CITY OF WEST LAKE HILLS, TEXAS
NOTICE OF BOARD OF ADJUSTMENT (BOA) REGULAR MEETING
Wednesday, October 8, 2025 at 7:00 PM

3. Administration Discuss and consider action on approval of the September 10, 2025 Regular Meeting Minutes.
4. Land Use 217 Reveille Road - Discuss and consider action on recommendations from ZAPCO on proposed variances:

5. **Land Use 207 Yaupon Valley Road** - Discuss and consider action on a recommendation from ZAPCO on variances:

6. **Land Use 1206 Yaupon Valley Road** - Discuss and consider action on a recommendation from ZAPCO on variances:

Request:

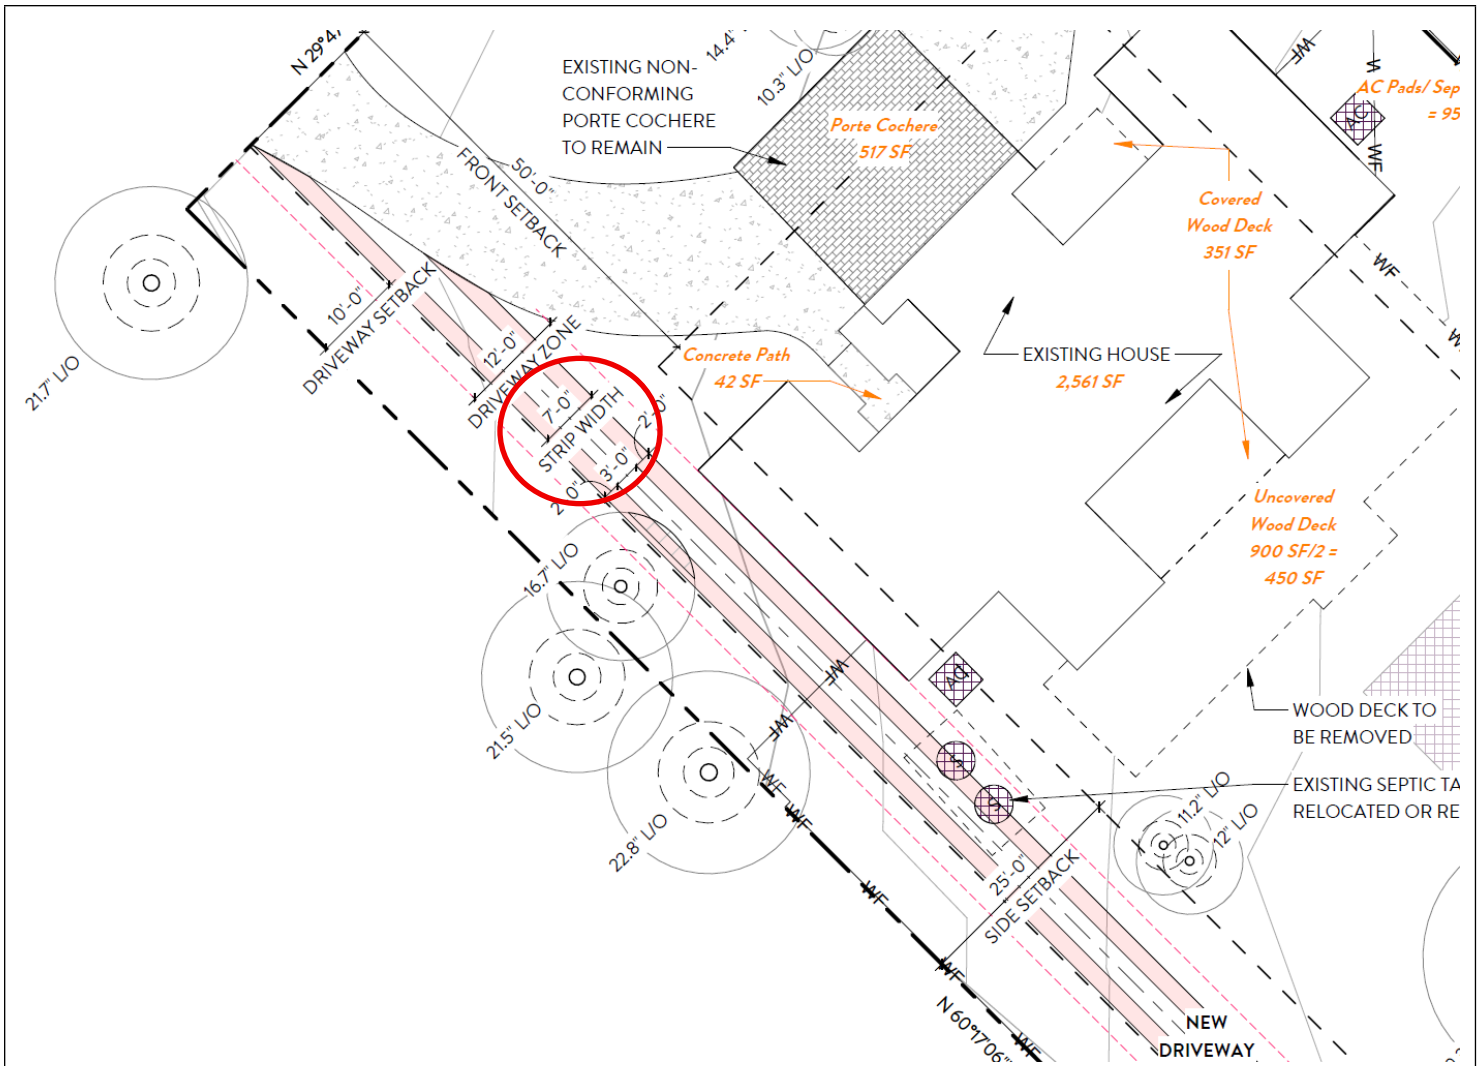
To construct driveway wheel strips that provide 7 feet of driving surface width. To construct a driveway of the required width, the site would go over the impervious cover maximum without removing existing impervious cover.

Request:

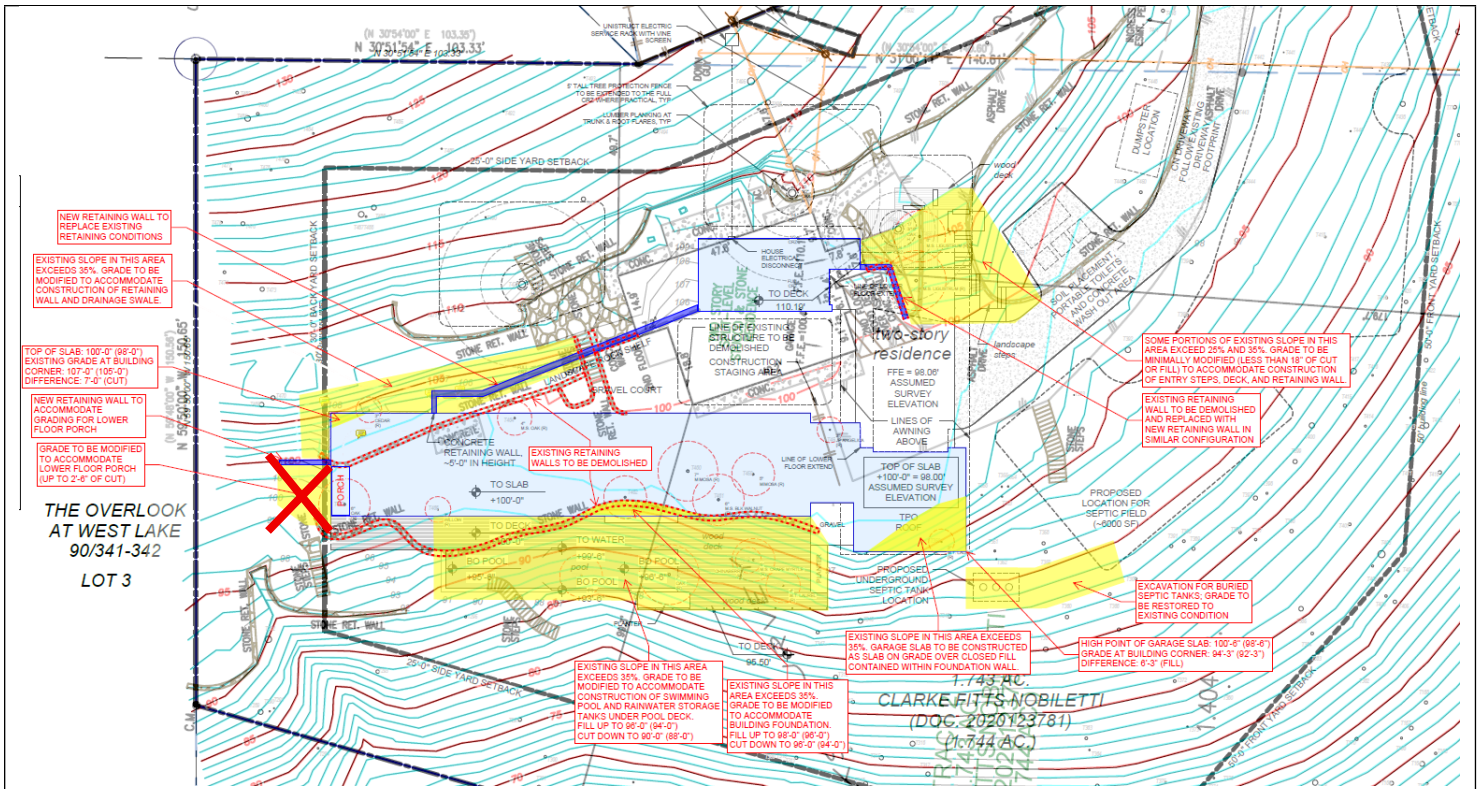
- Allow for grading on a slope of 35% or greater
 The areas in yellow indicate areas where the slope exceeds 35% slope.

Site Plan with Slope Study
p. 2

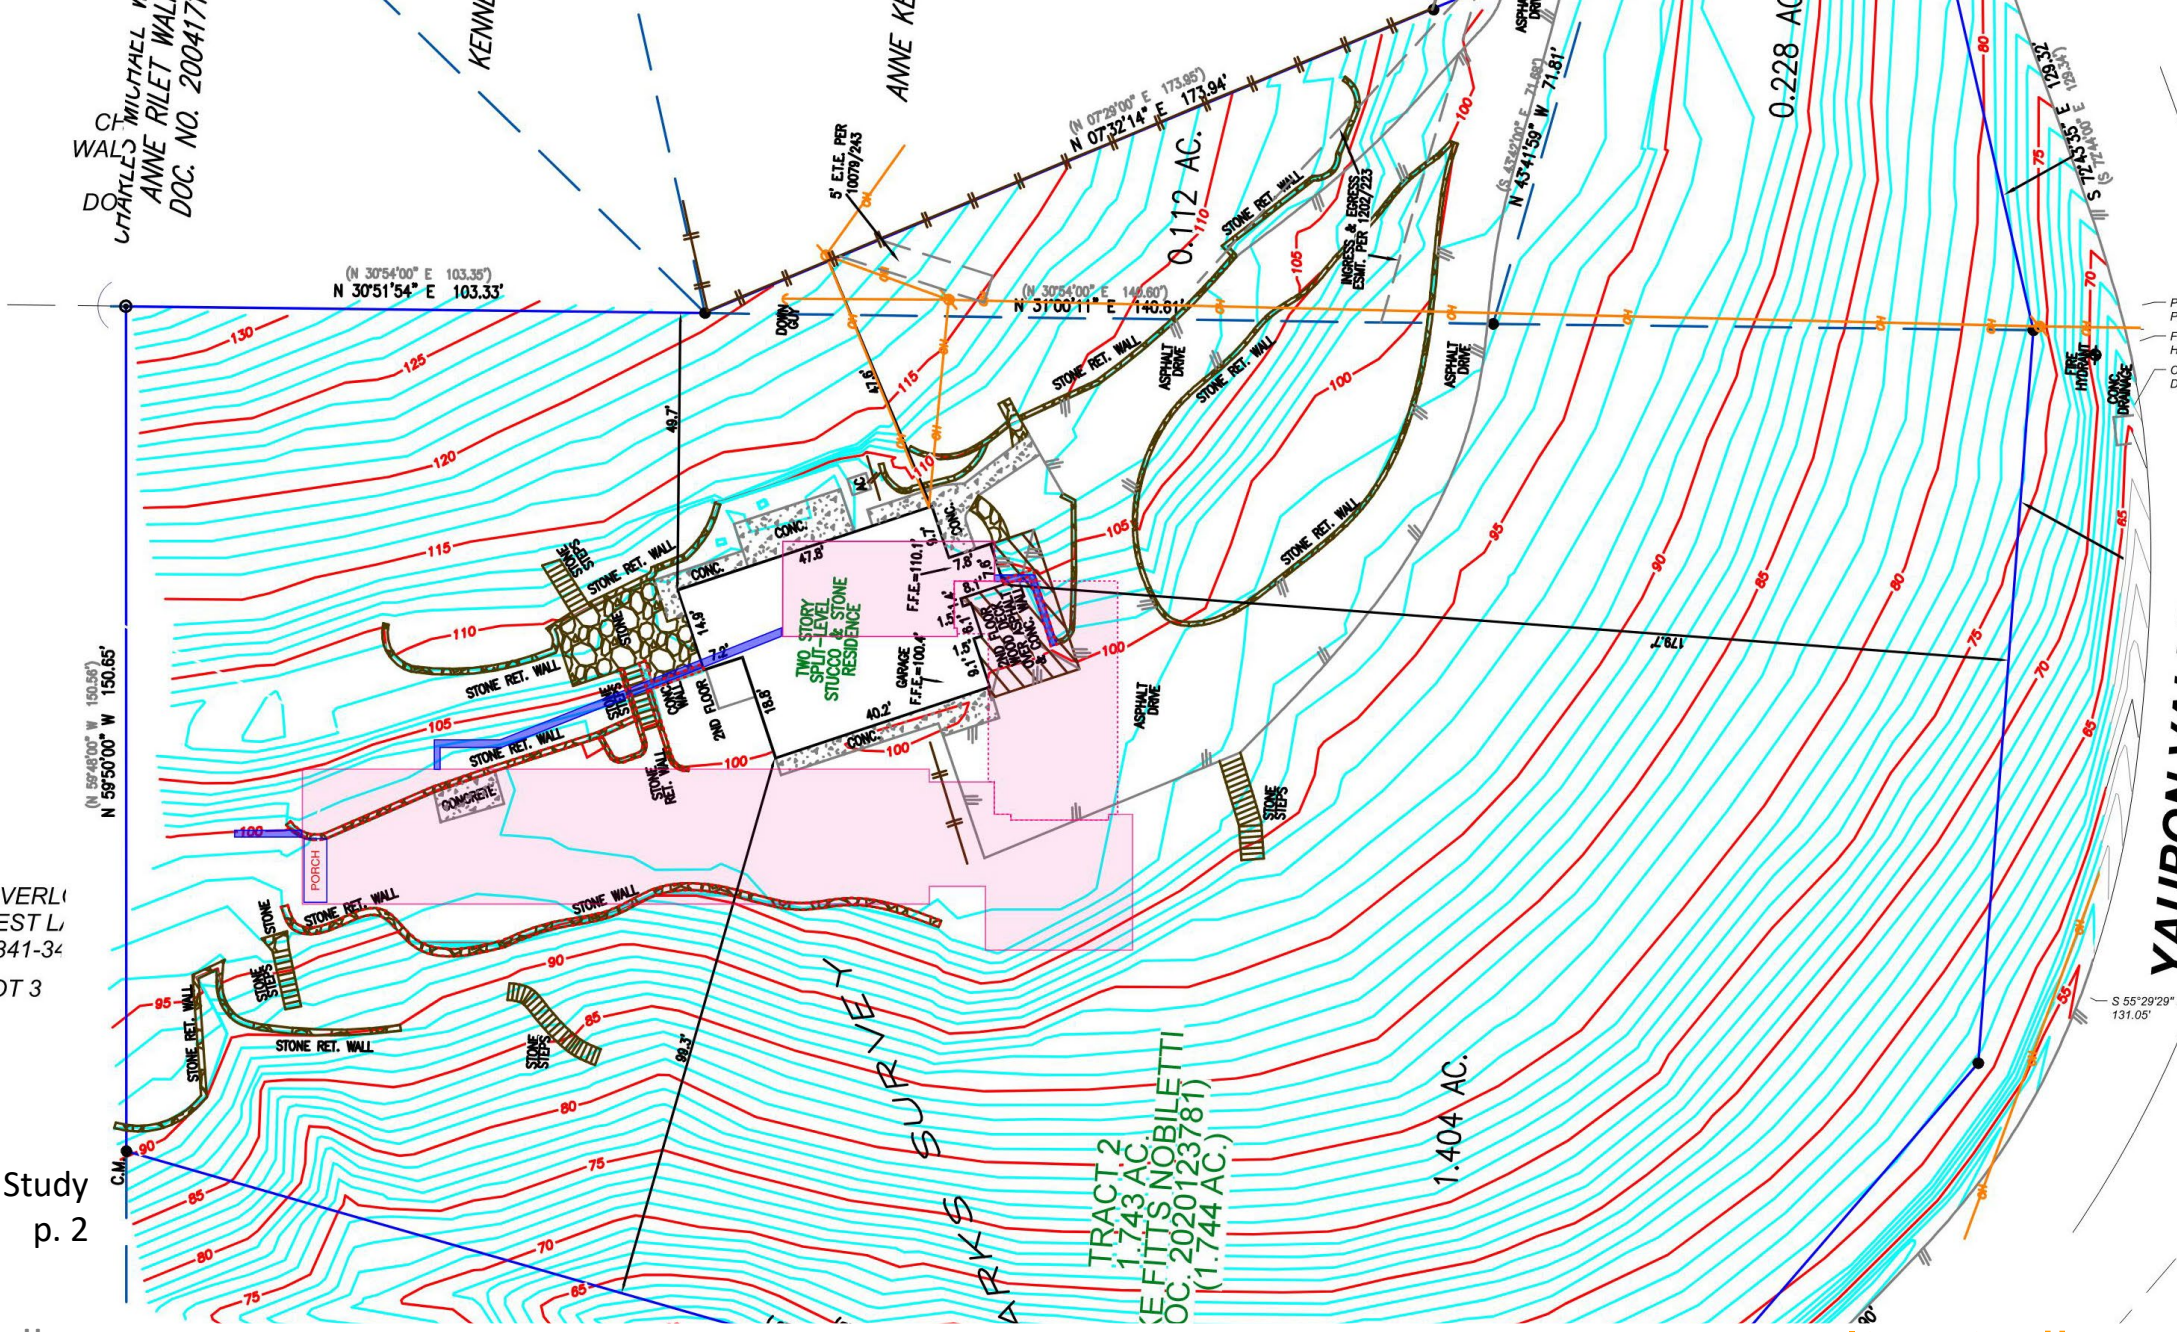
Please refer to Exhibit OSU A0.03 site plan w slope study.

Response: As it can be observed on the site plan, there are all small areas of the site that contain slopes greater than 35%, contained within a couple of parallel subterranean rock ledges that run through out the site. The building primarily sits on the shelf contained between ledges and the building creeps out into the 35% slope areas on the site plan that are indicated with a yellow screen hatch. As it can be seen on the site plan diagram these areas are minimal, but can also be observed that architects worked very hard to try and keep the footprint of the building from encroaching into these areas as best as possible.

- The City Engineer has recommended approval of the variance based on the design engineer's letter that there are no adverse impacts of the properties downstream and no adverse impact to erosion on site
- Will verify calculations on final drawings.

Pool and Rainwater Tanks
p. 7

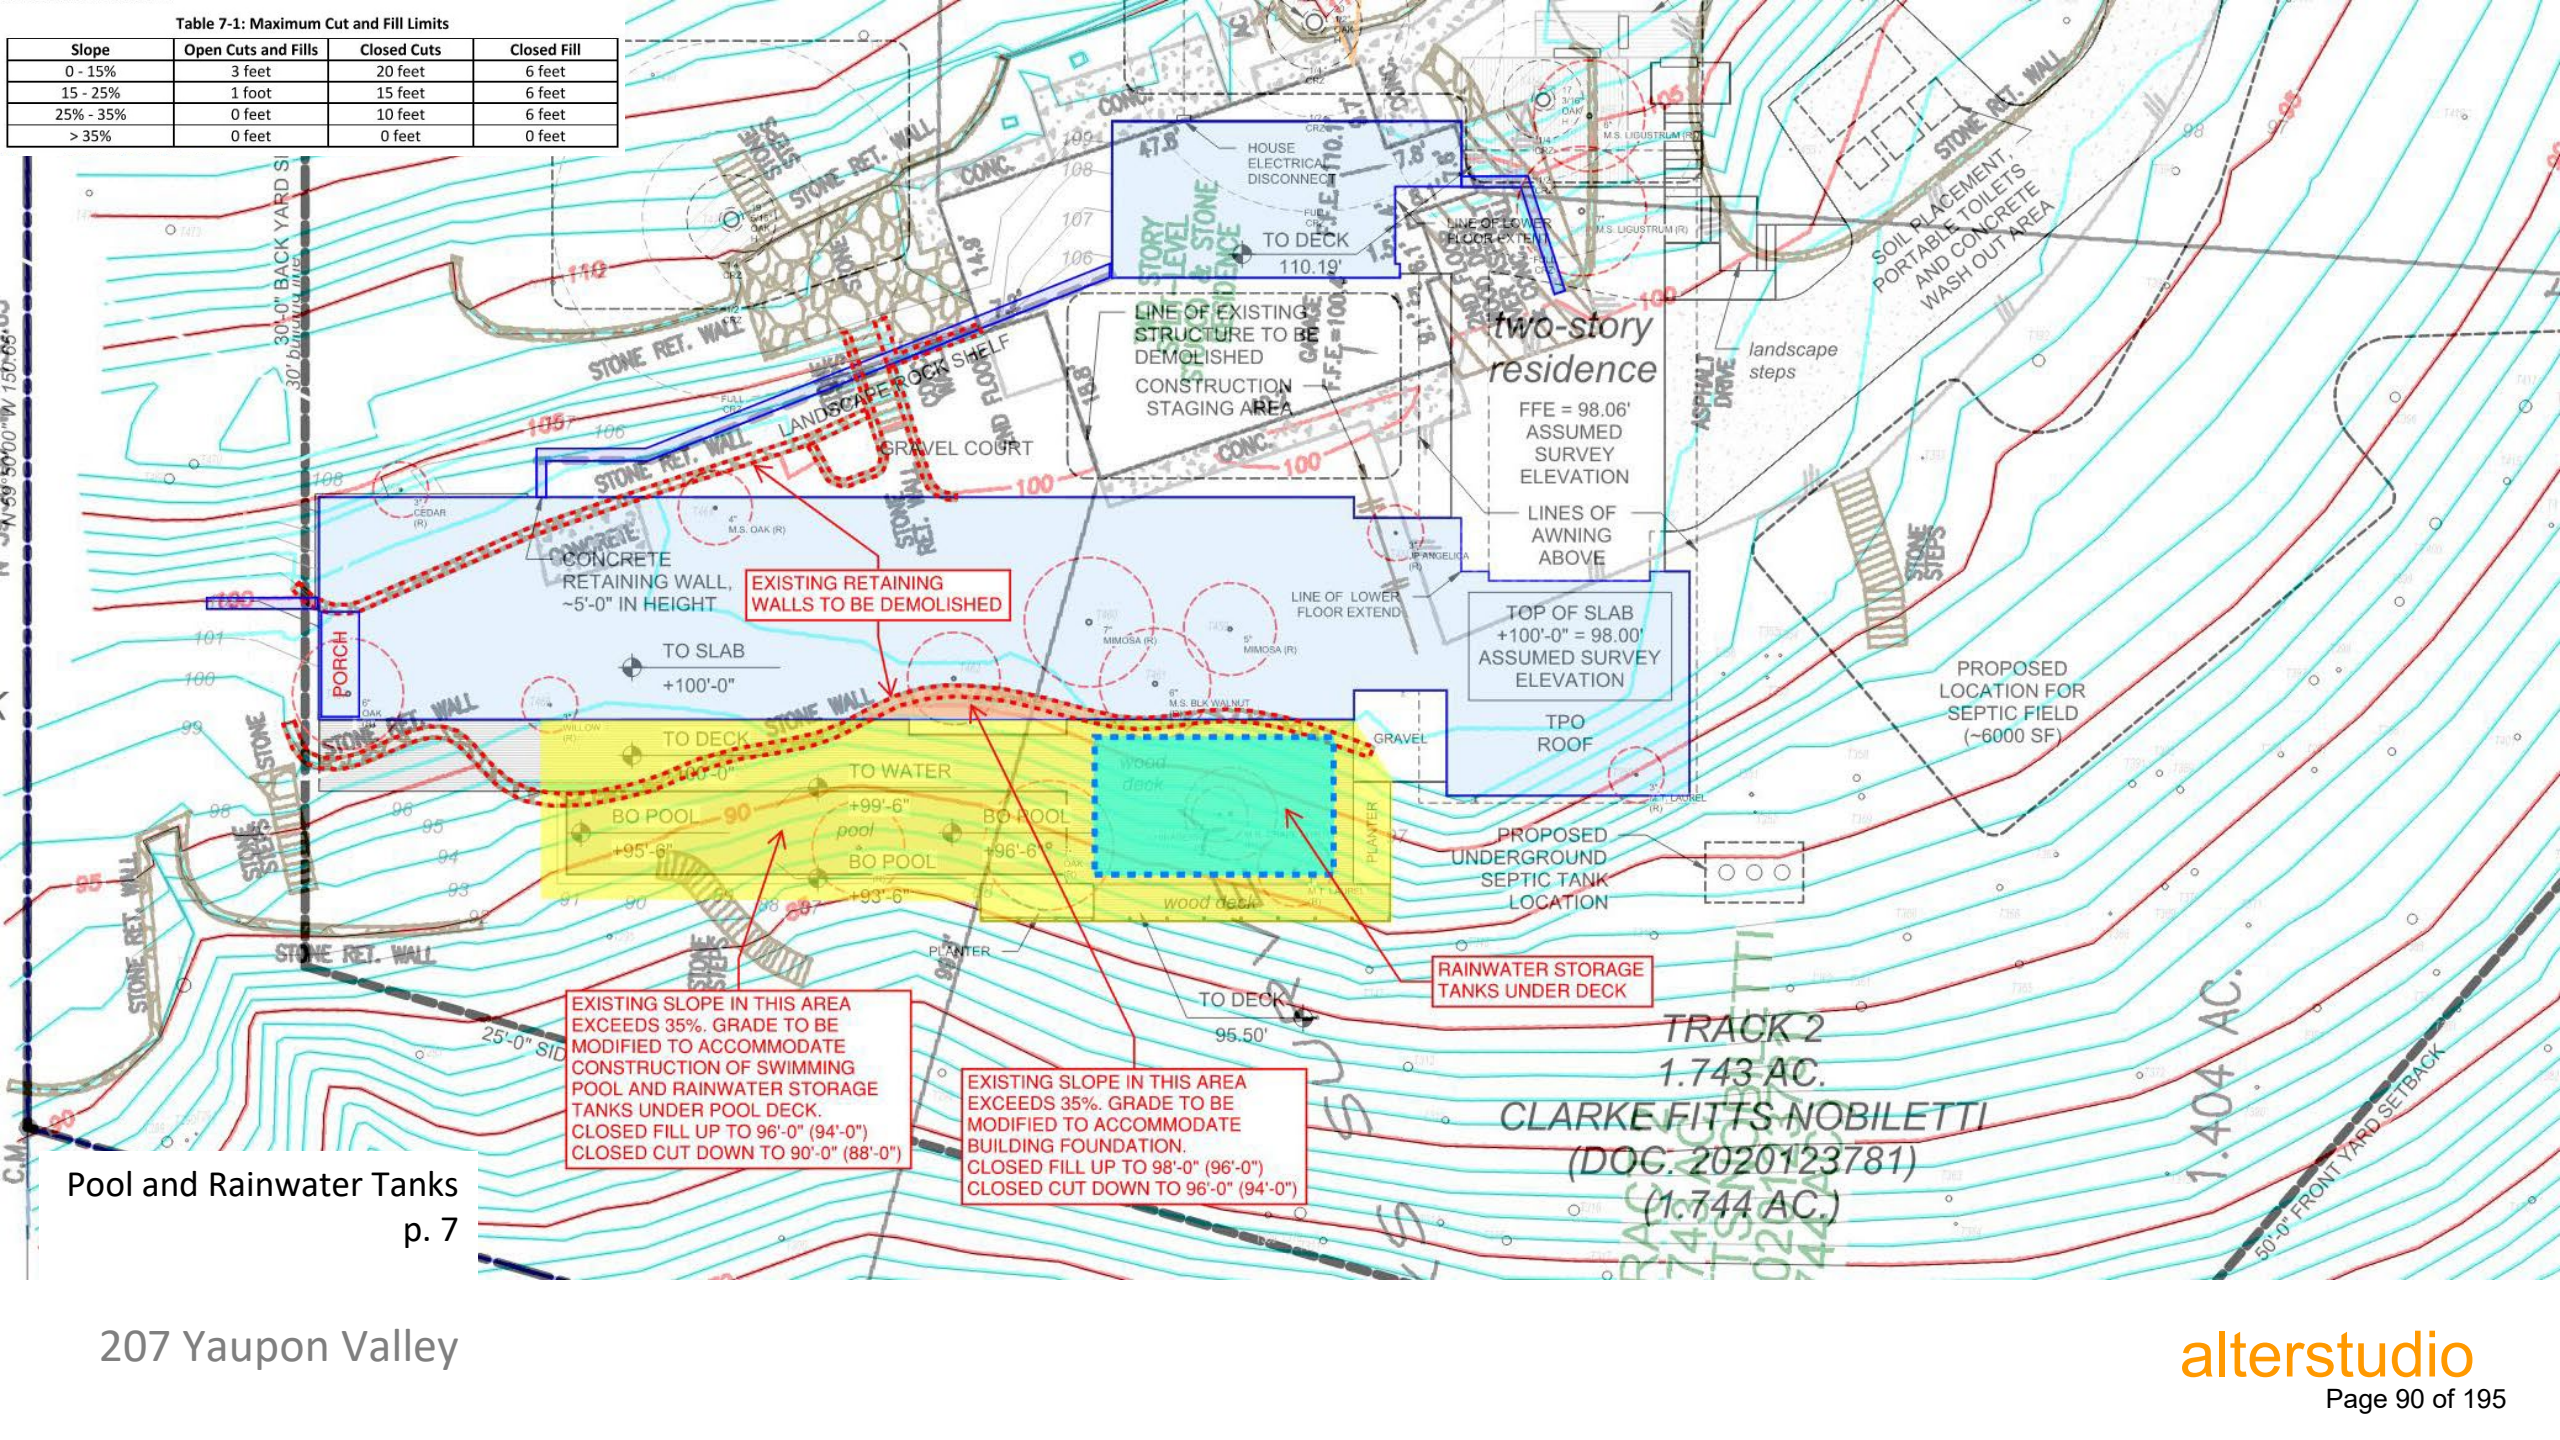
- EXISTING SLOPE IN THIS AREA EXCEEDS 35%. GRADE TO BE MODIFIED TO ACCOMMODATE CONSTRUCTION OF SWIMMING POOL AND RAINWATER STORAGE TANKS UNDER POOL DECK. FILL UP TO 96'-0" (94'-0") CUT DOWN TO 90'-0" (88'-0")
- EXISTING SLOPE IN THIS AREA EXCEEDS 35%. GRADE TO BE MODIFIED TO ACCOMMODATE BUILDING FOUNDATION. FILL UP TO 98'-0" (96'-0") CUT DOWN TO 96'-0" (94'-0")
- EXISTING SLOPE IN THIS AREA EXCEEDS 35%. GARAGE SLAB TO BE CONSTRUCTED AS SLAB ON GRADE OVER CLOSED FILL CONTAINED WITHIN FOUNDATION WALL
- EXCAVATION FOR BURIED SEPTIC TANKS. GRADE TO BE RESTORED TO EXISTING CONDITION
